City of Timmins

ADDENDUM #3

Bid Opportunity: 1155 – Timmins Water Filtration Plant High Lift & Backwash Pump Replacement

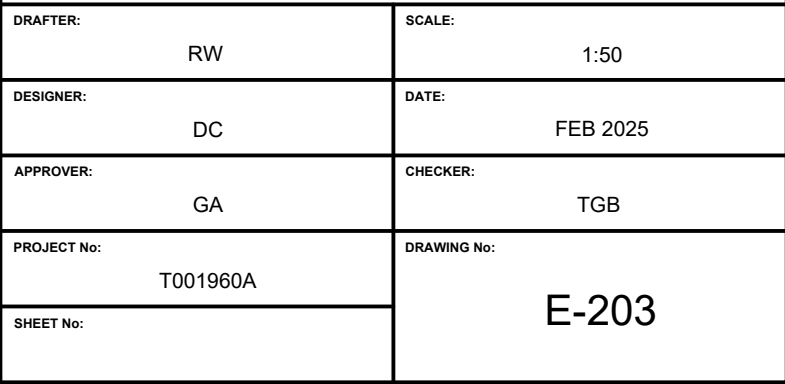
Do you require a ground ran throughout the cable tray? If so what size?

No, a ground run throughout the cable tray is not required. However, cable tray should be bonded per Rule 10-600. Size of bonding conductor is to be determined by Table 16.

SHEET TITLE:
OVERALL UPPER LEVEL PLAN
POWER LAYOUT -
NEW MAJOR FEEDERS
ROUTES

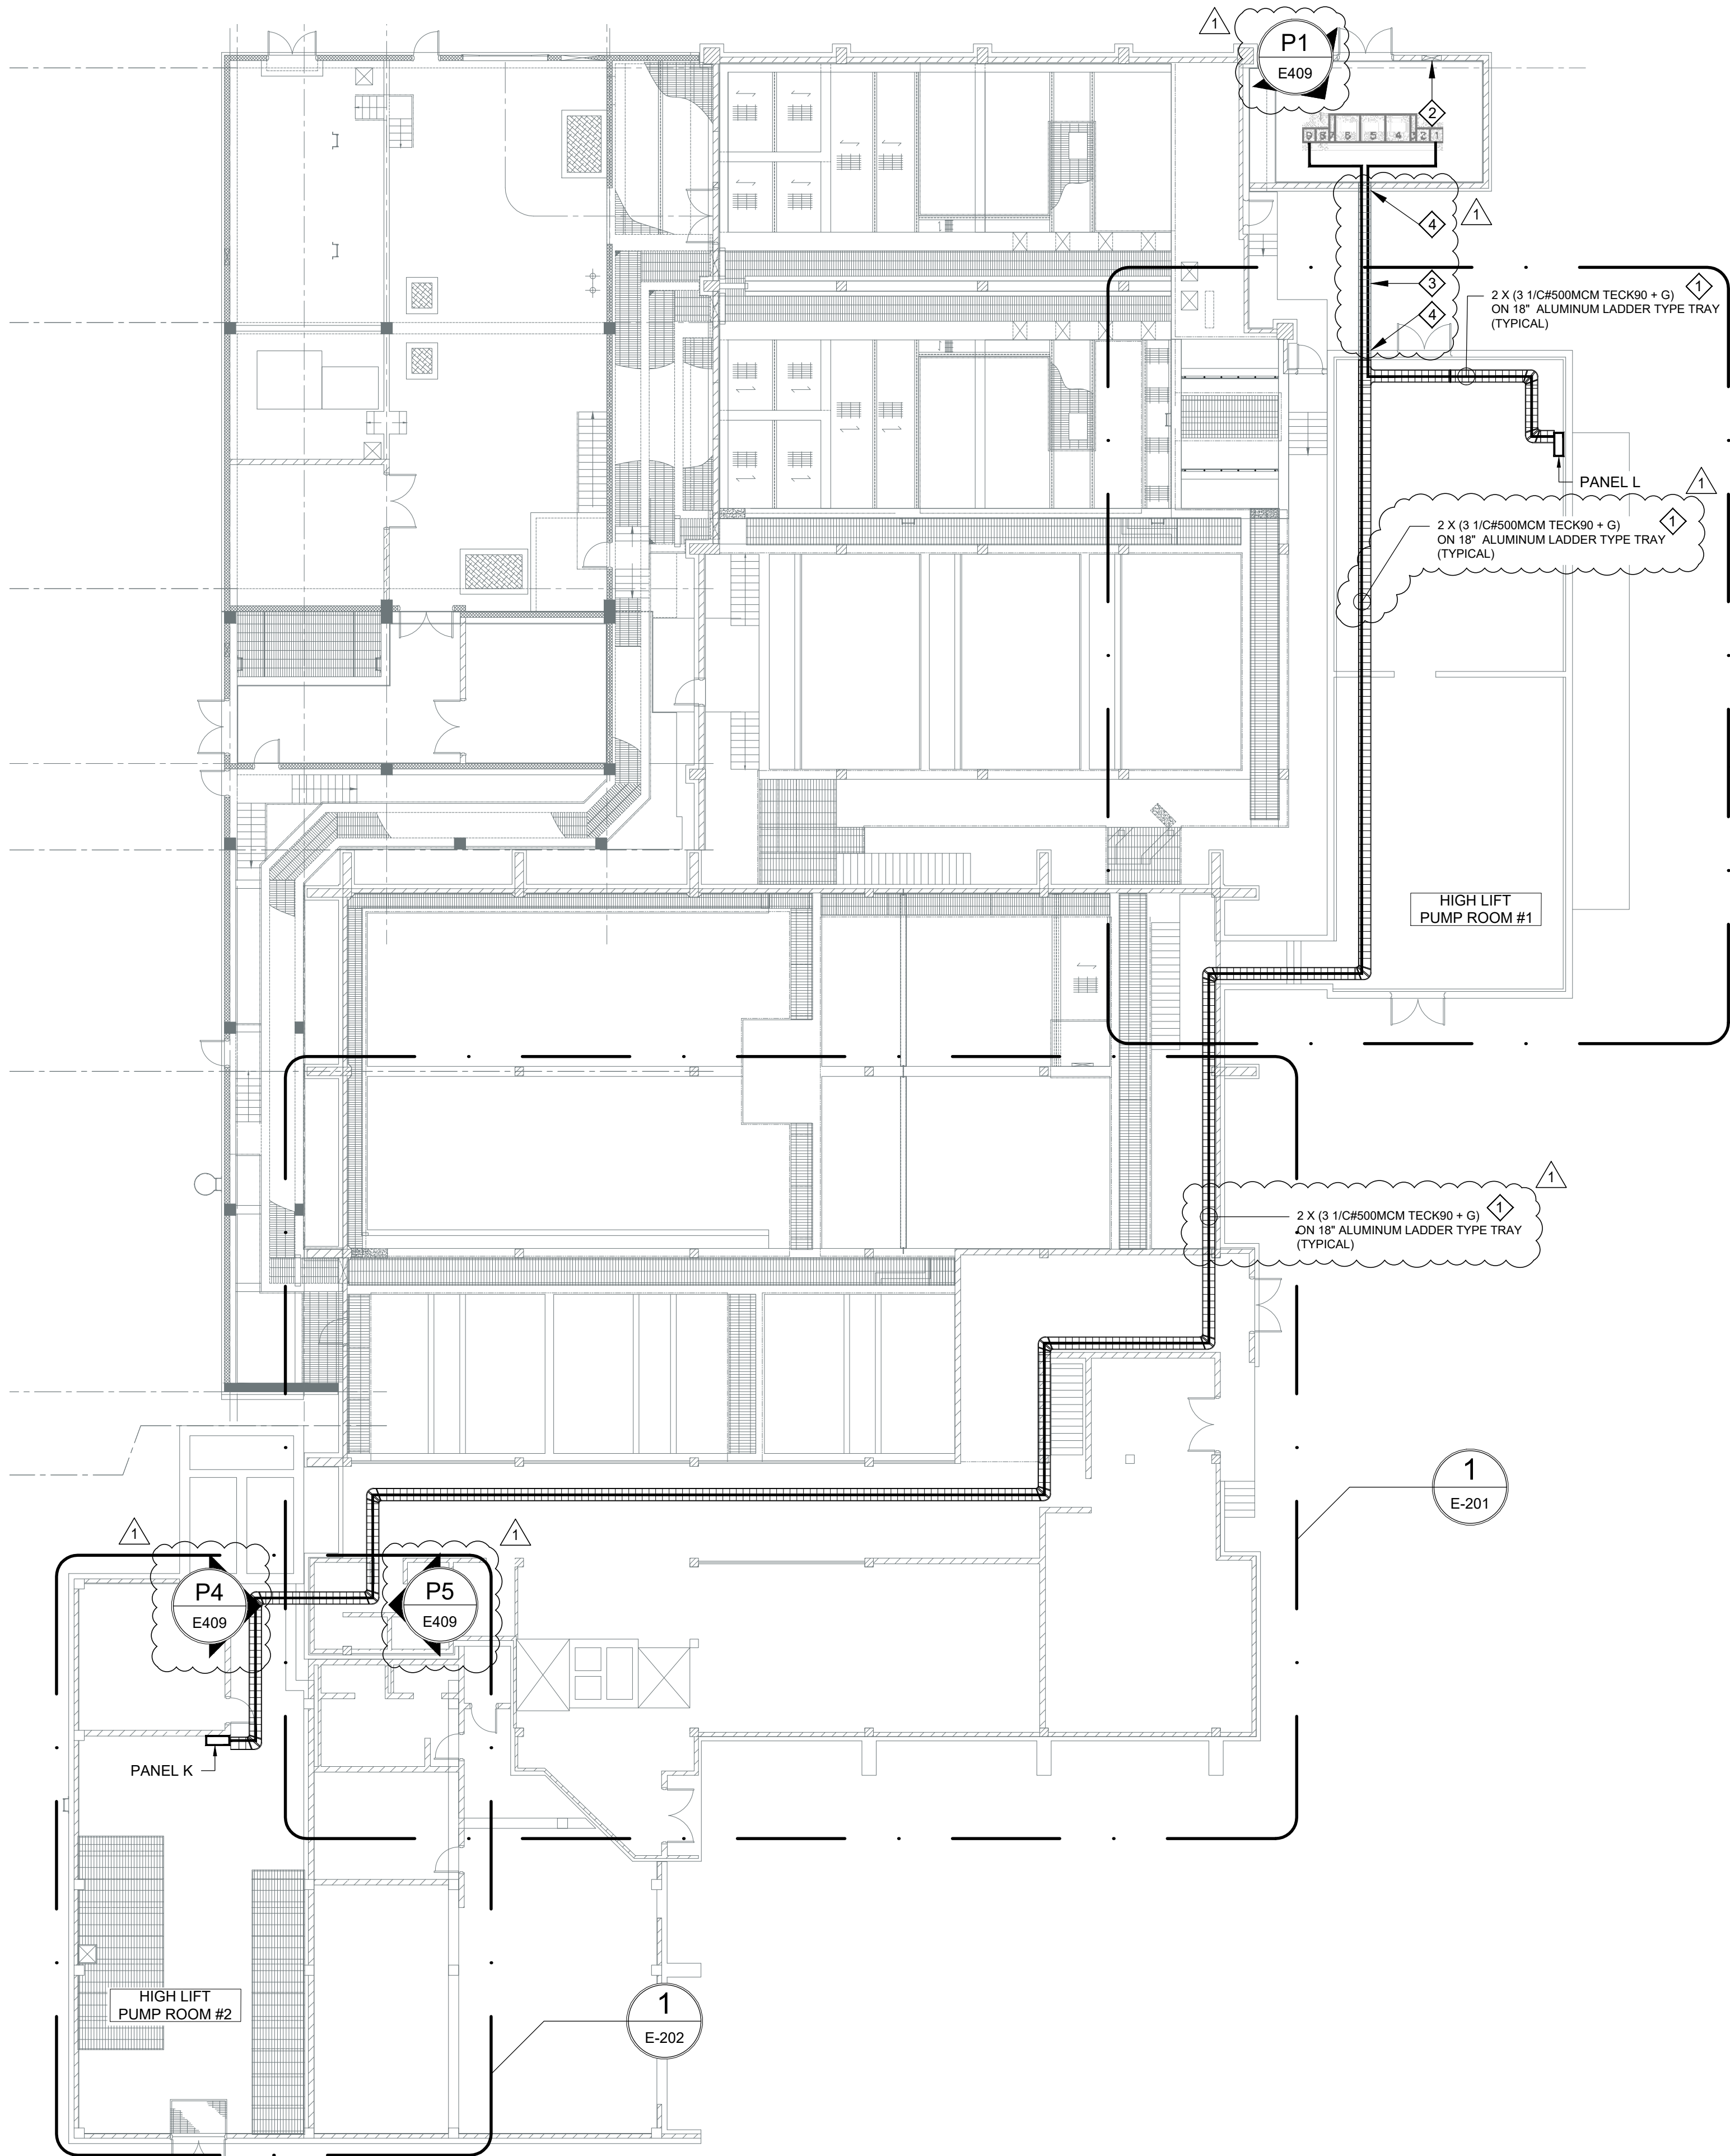
2. **DELETE** Drawing S-501 in its entirety and **REPLACE** with Drawing S-501 included as part of this Addendum.
3. **DELETE** Drawings E-001, E-203, E-210, E-304, E-306, E-401, E-402 and E-409 included as part of this Addendum.

- DRAWING NOTES:
- THE SINGLE CONDUCTOR CABLES SHALL BE INSTALLED TO MAINTAIN FREE AIR AMPACITY RATING. REFER TO TYPICAL DETAIL 4/E401 (PROVIDE WALL PENETRATIONS AND FIRE SEAL ALONG THE NEW CABLE TRAY RUN AS REQUIRED. COORDINATE WITH EXISTING SERVICES IN CEILING SPACE).
 - PROVIDE UPDATED SINGLE LINE DIAGRAM FULL SIZE DRAWING IN FRAME. THE DRAWING SHALL BE POSTED IN ELECTRICAL ROOM.
 - THE TWO (2) NEW CABLE TRAYS SHALL SPAN IN THE OPEN SPACE BETWEEN TWO BUILDINGS AND BE INSTALLED BELOW EXISTING CABLE TRAY. PROVIDE SHOP DRAWINGS FOR THE REINFORCEMENT REQUIRED TO SUPPORT THE CABLES WEIGHT. THIS SHOP DRAWING SHALL BE STAMPED BY A STRUCTURAL ENGINEER.
 - PROVIDE EXTERIOR WALL PENETRATION AND FIRE/ WEATHER SEAL FOR THE NEW CABLE TRAYS. REFER TO DETAIL 5 ON DRAWING S-501.
